ADDENDUM NO. 03

TO: PLANS AND SPECIFICATIONS FOR STATE OF MISSOURI

Replace Fire Alarm System, Infrastructure
Farmington Correctional Center
PROJECT NO.: C2503-01

1 BUILDING 4 - LEVEL 1 - FIRE ALARM
1/8" = 1'-0"

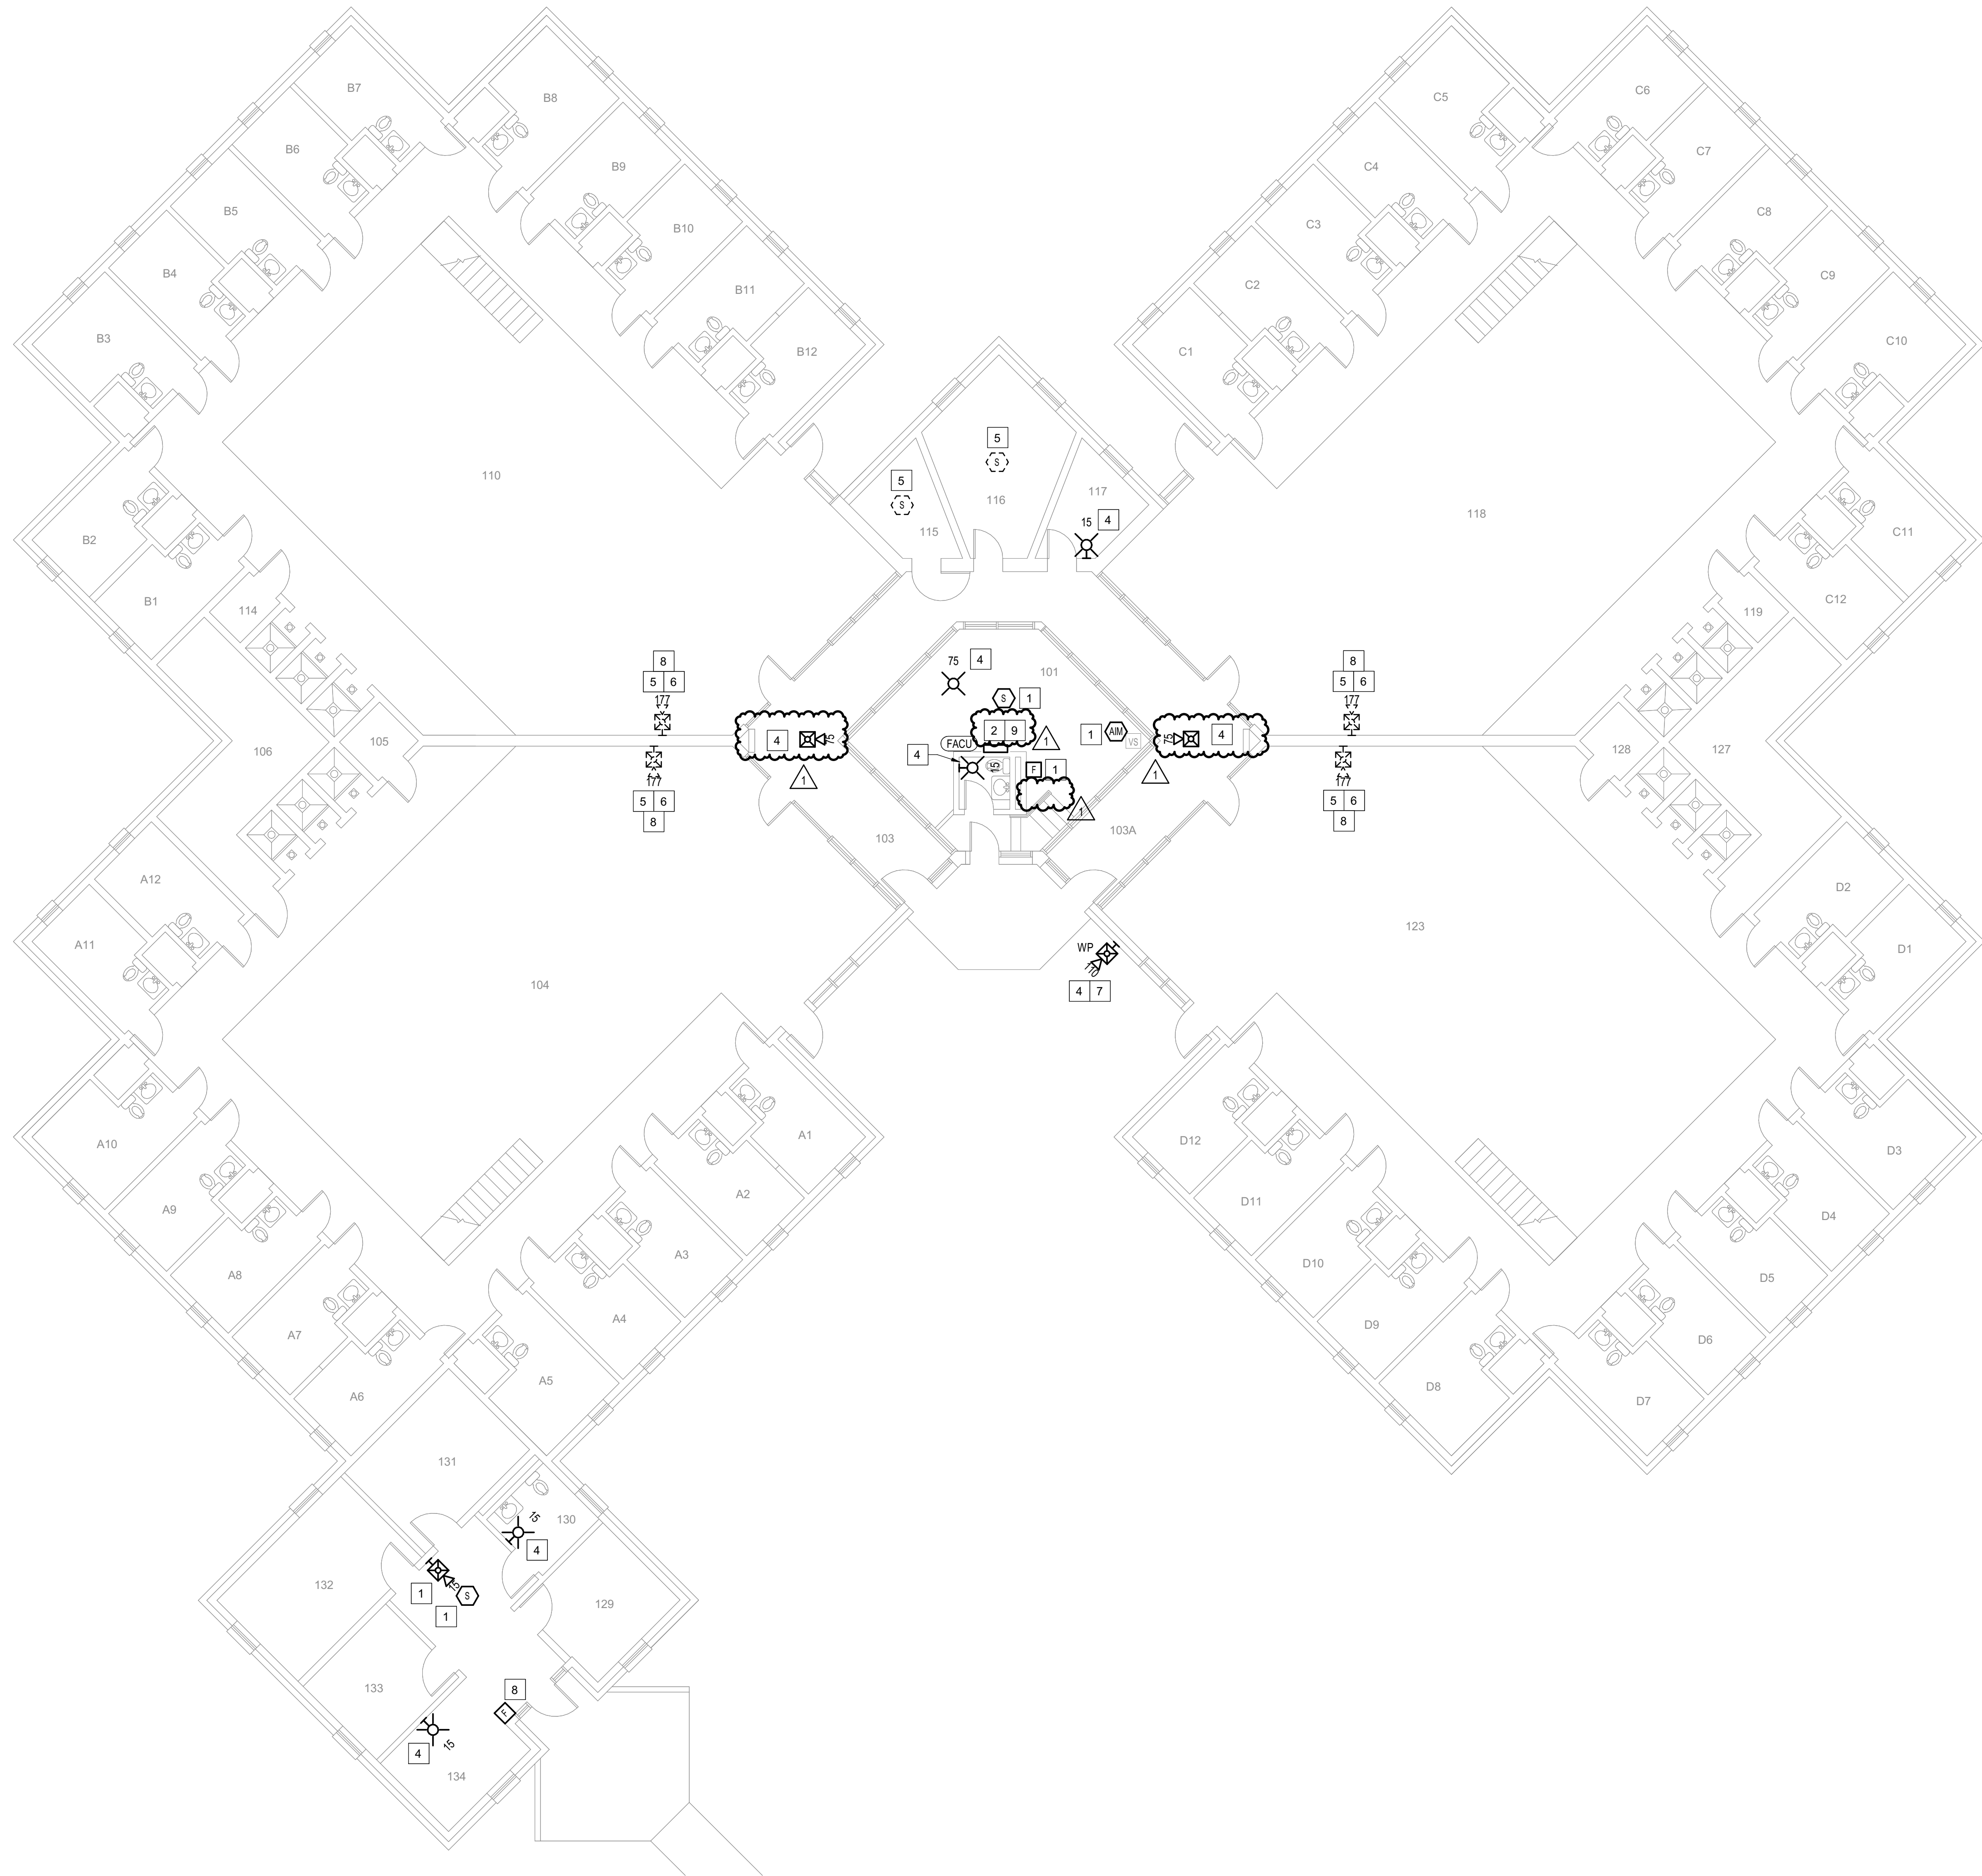
- a. GENERAL SHEET NOTE #2 REMOVED
 - b. NOTIFICATION DEVICES IN THE INNER CORRIDOR SHIFTED TO CEILING MOUNTED.
 - c. OLD EXISTING FIBER CABINET REMOVED FROM PLAN TO AVOID CONFUSION WITH NEW FIBER CABINETS.

- d. SHEET KEYNOTE #9 ADDED
 - e. SHEET KEYNOTE #2 MODIFIED
12. FA108 – BUILDING 4 – LEVEL 1 MEZZANINE – FIRE ALARM
- a. GENERAL SHEET NOTE #2 REMOVED
13. FA109 – BUILDING 5 - LEVEL 1 – FIRE ALARM

FA109

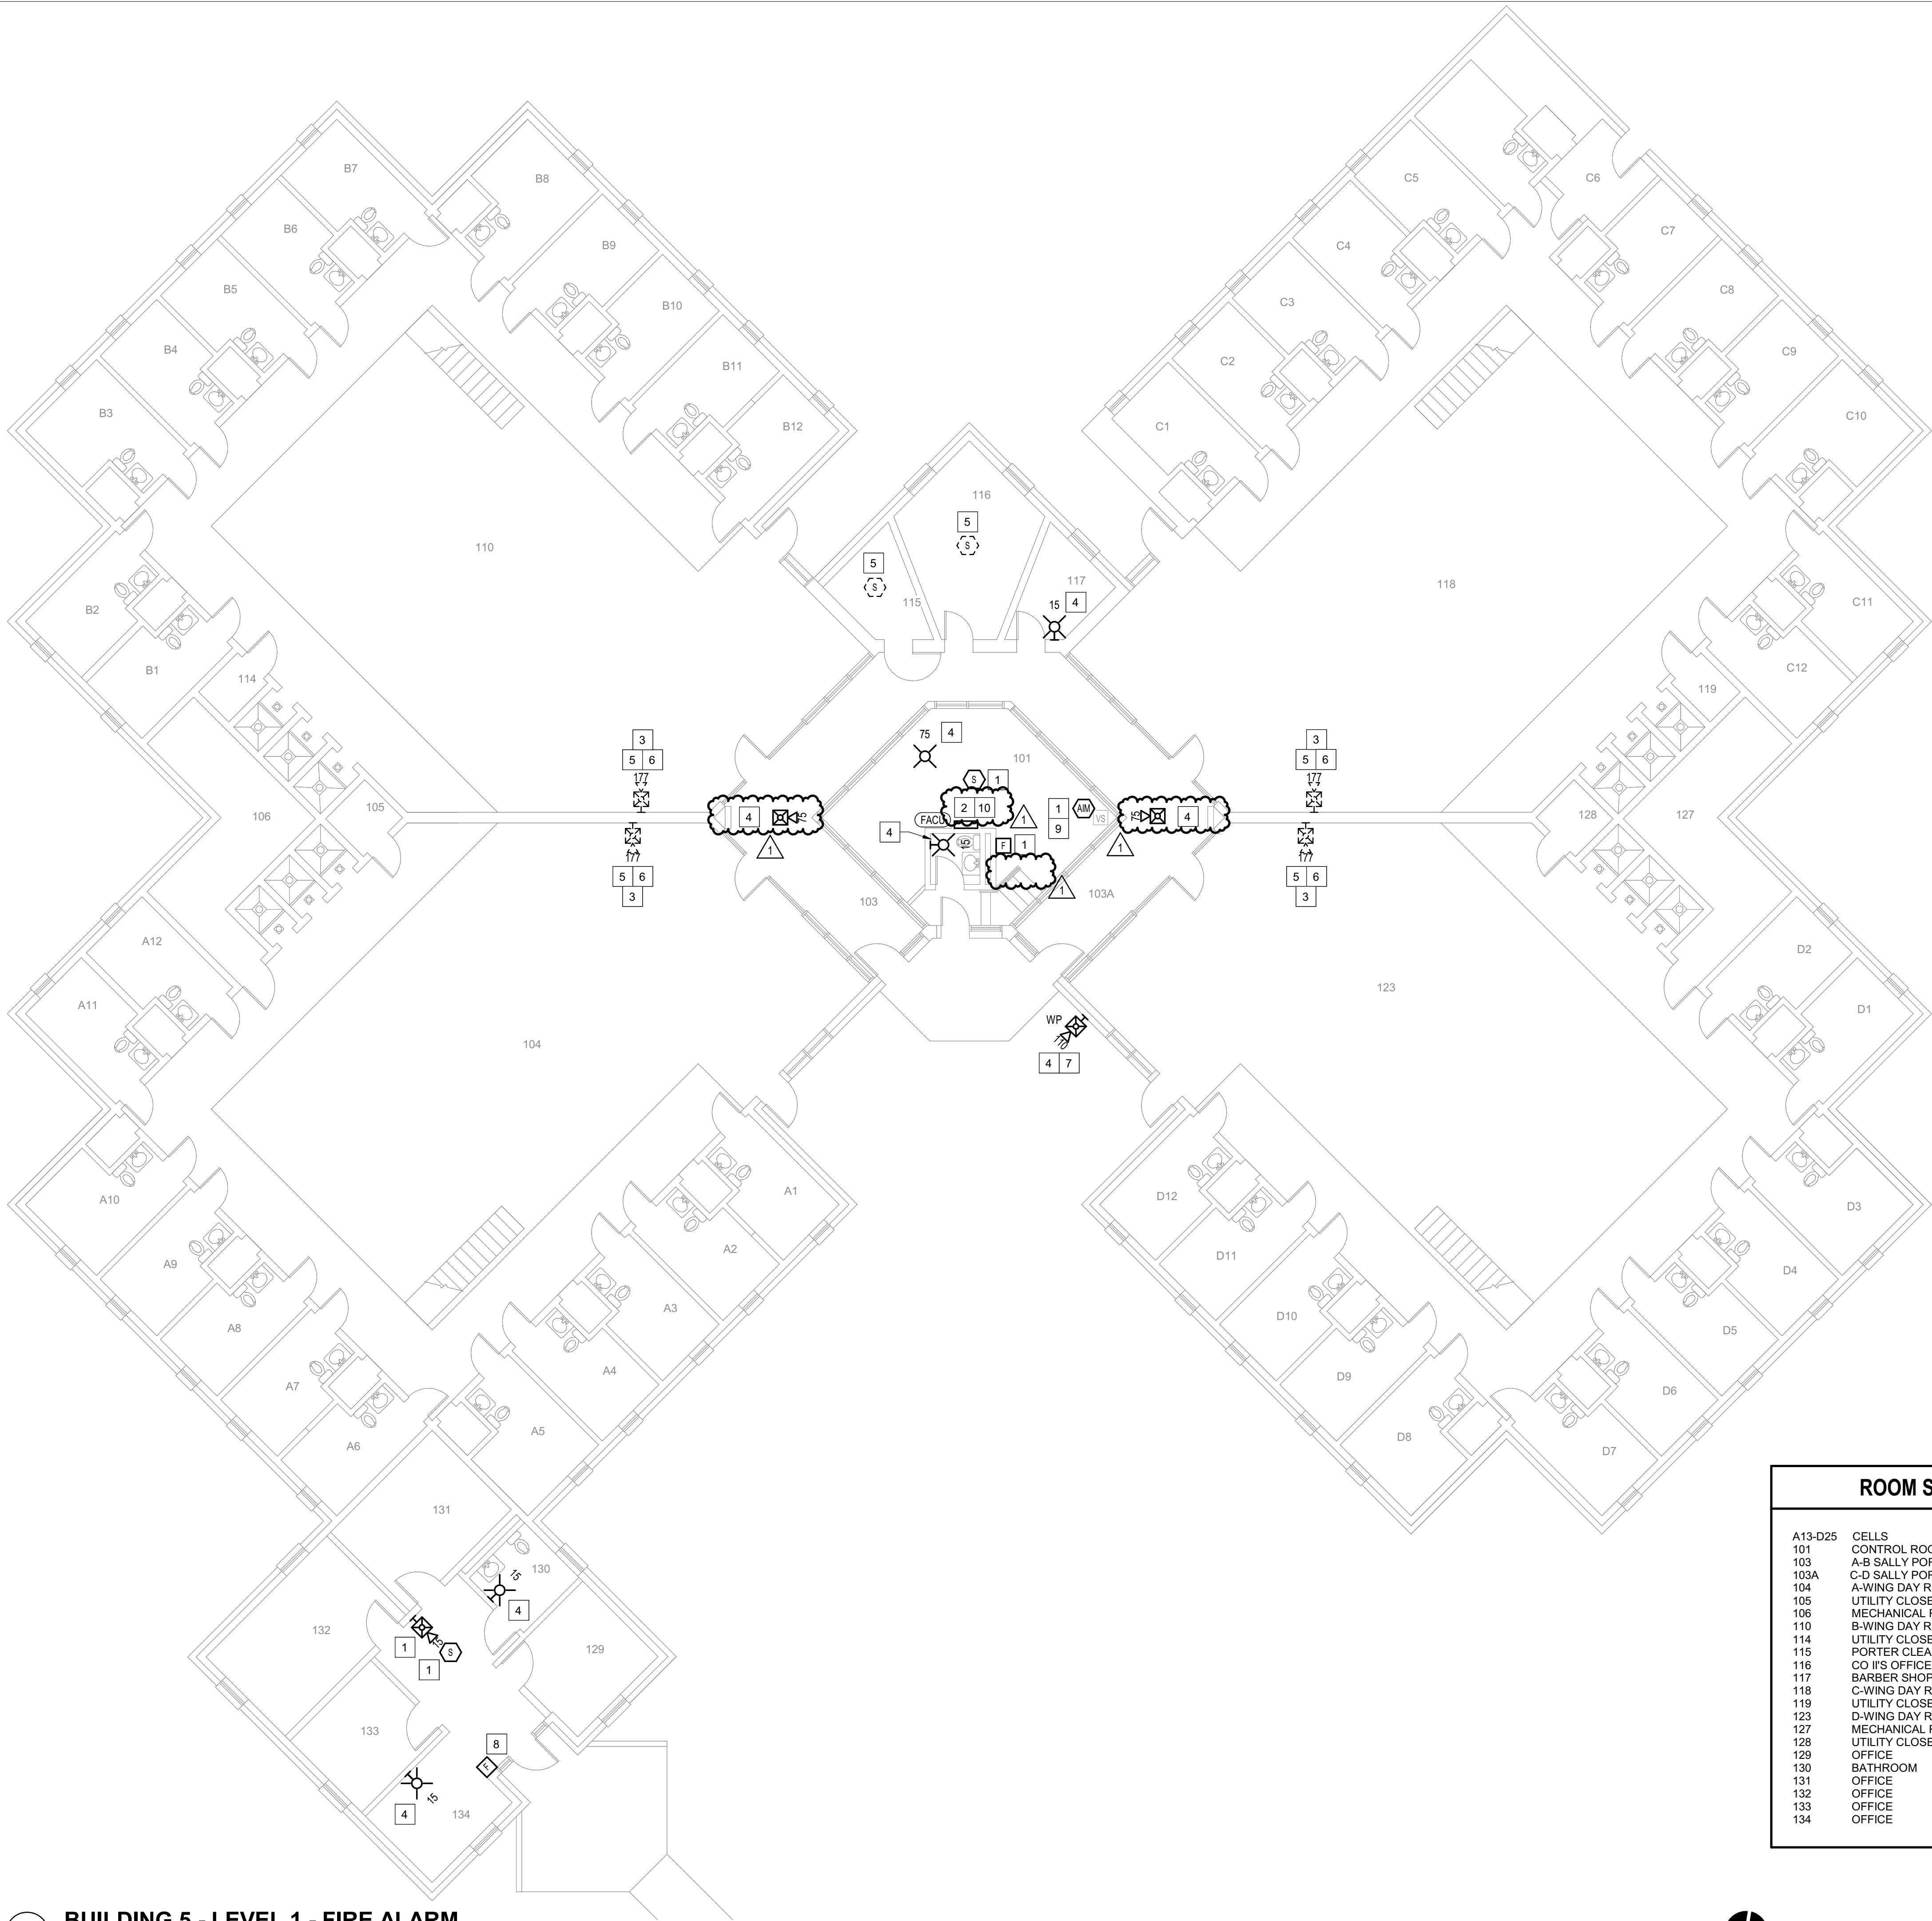
- a. GENERAL SHEET NOTE #2 REMOVED
 - b. NOTIFICATION DEVICES IN THE INNER CORRIDOR SHIFTED TO CEILING MOUNTED.
 - c. OLD EXISTING FIBER CABINET REMOVED FROM PLAN TO AVOID CONFUSION WITH NEW FIBER CABINETS.

- d. SHEET KEYNOTE #10 ADDED
 - e. SHEET KEYNOTE #2 MODIFIED
14. FA110 – BUILDING 5 – LEVEL 1 MEZZANINE – FIRE ALARM
- a. GENERAL SHEET NOTE #2 REMOVED
15. FA111 – BUILDING 6 - LEVEL 1 – FIRE ALARM

1 **BUILDING 6 - LEVEL 1 - FIRE ALARM**
1/8" = 1'-0"

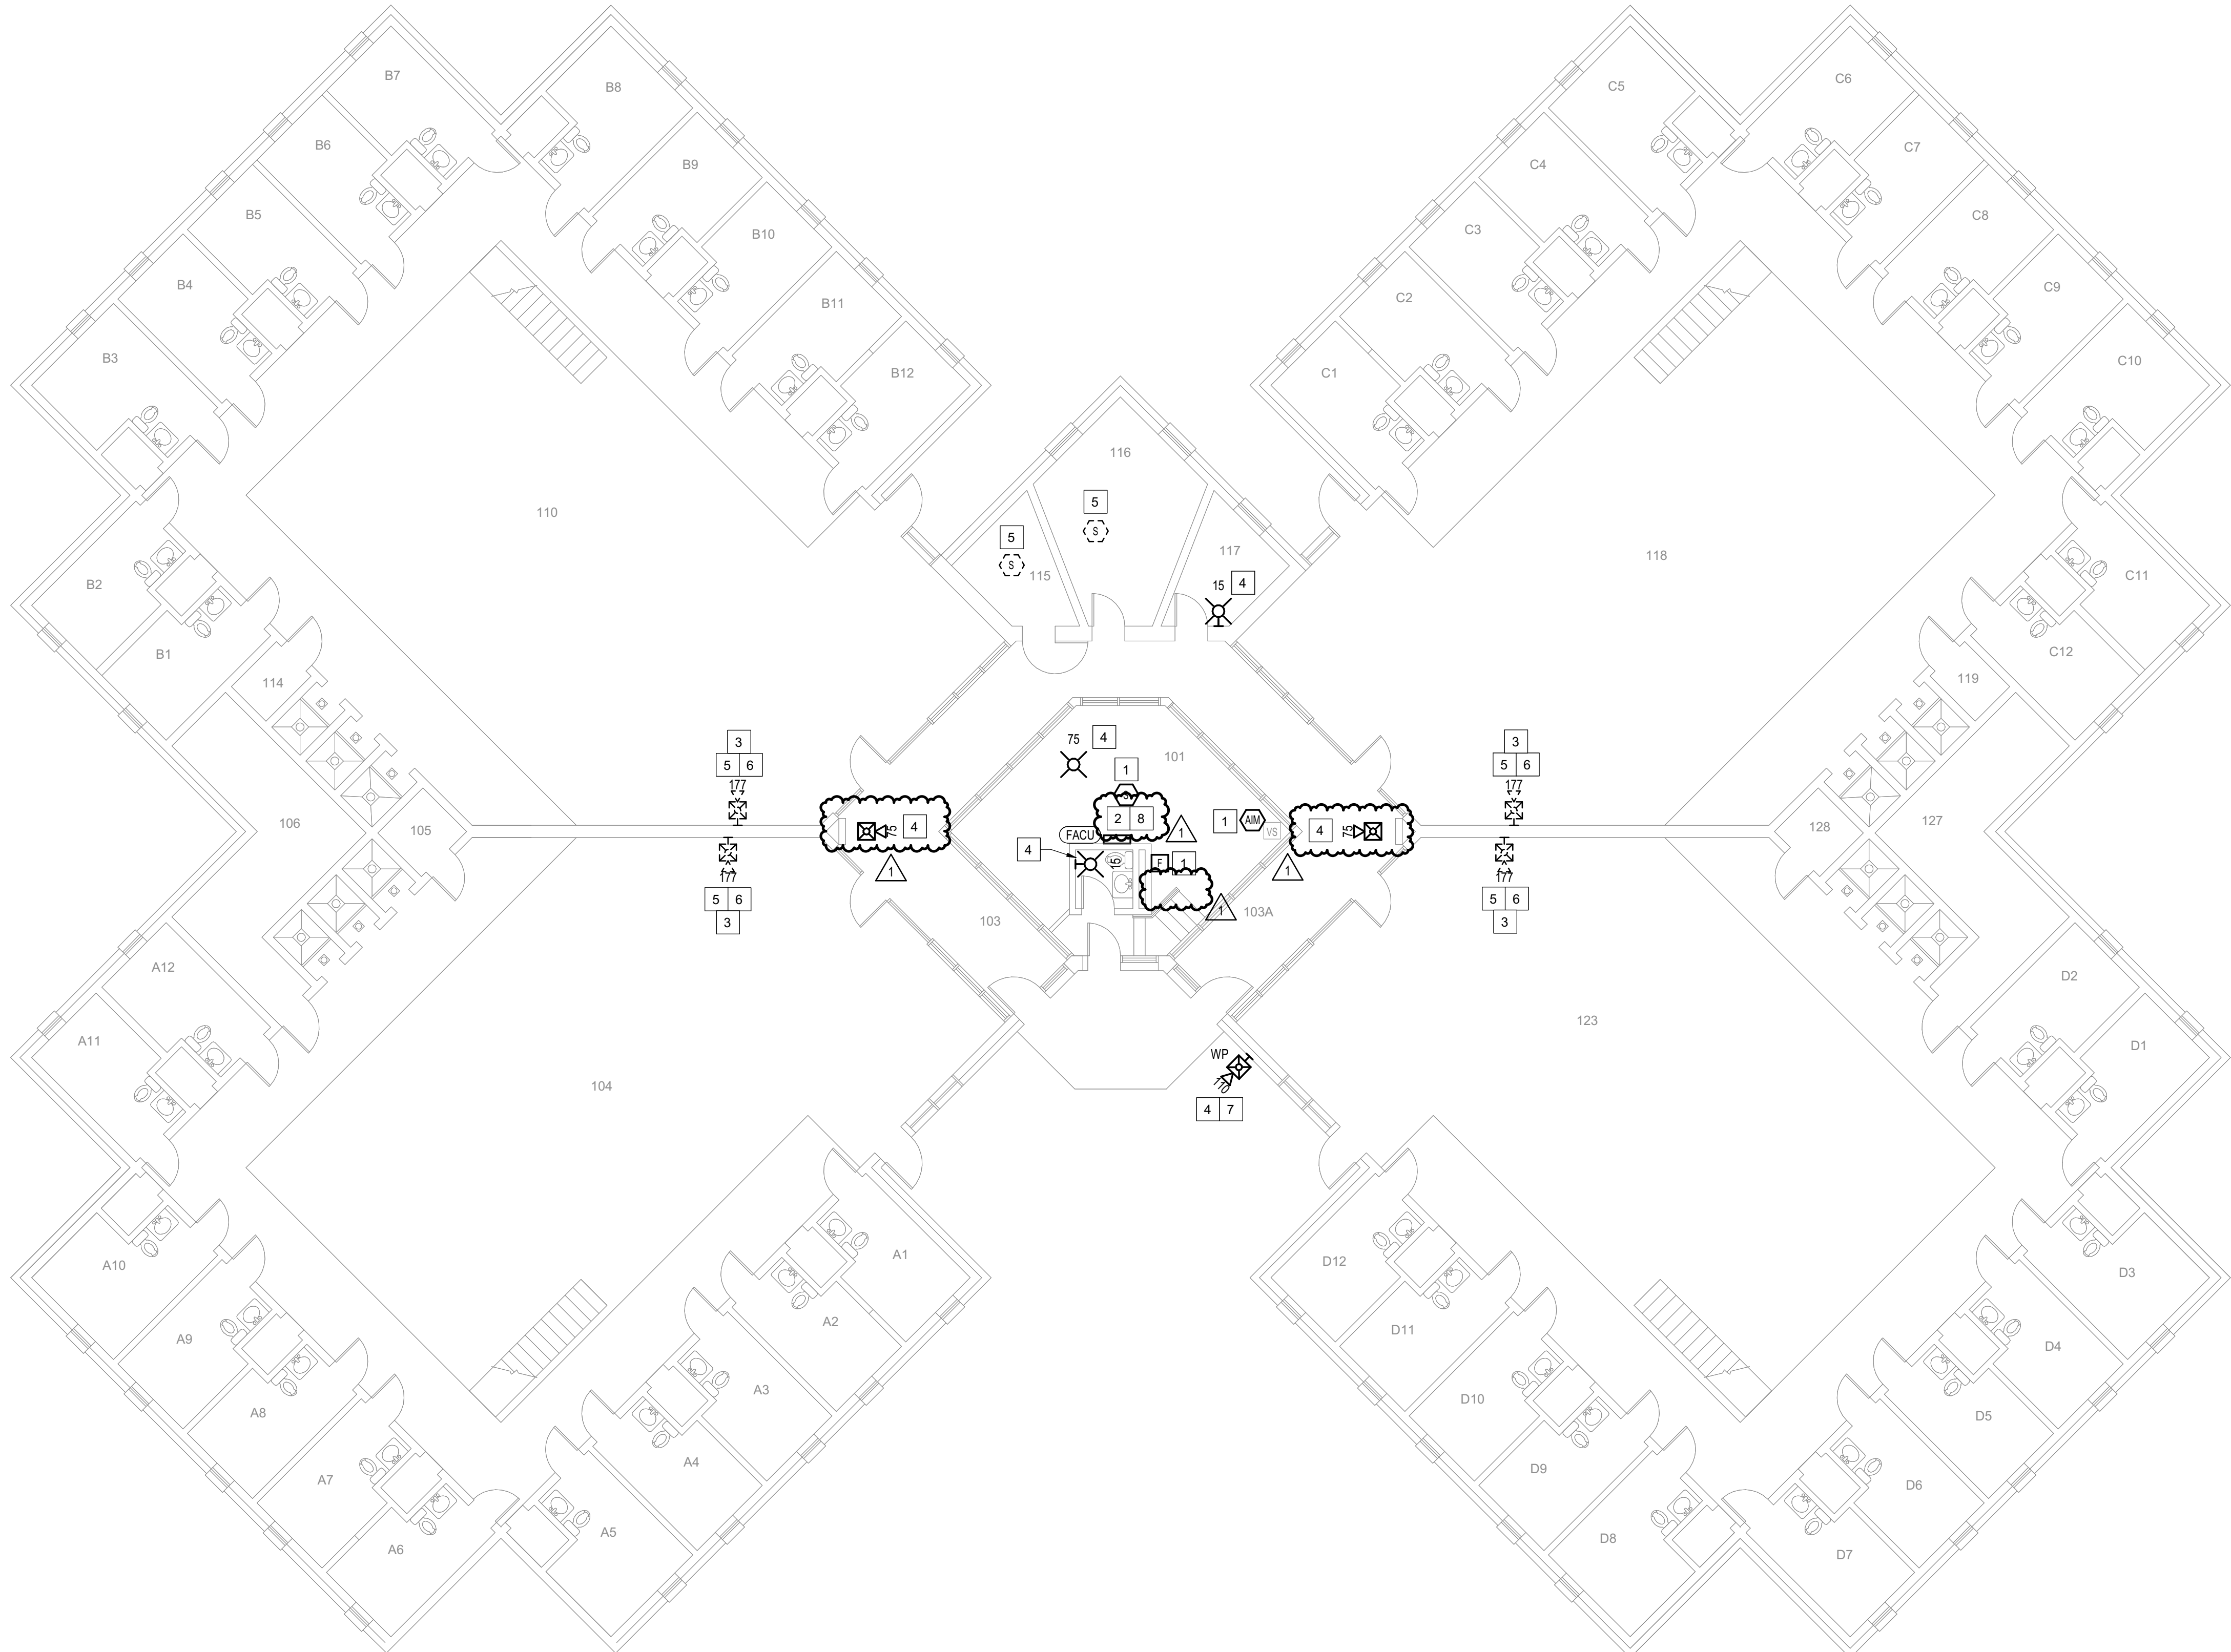
- a. GENERAL SHEET NOTE #2 REMOVED
 - b. NOTIFICATION DEVICES IN THE INNER CORRIDOR SHIFTED TO CEILING MOUNTED.
 - c. OLD EXISTING FIBER CABINET REMOVED FROM PLAN TO AVOID CONFUSION WITH NEW FIBER CABINETS.

- d. SHEET KEYNOTE #8 ADDED
 - e. SHEET KEYNOTE #2 MODIFIED
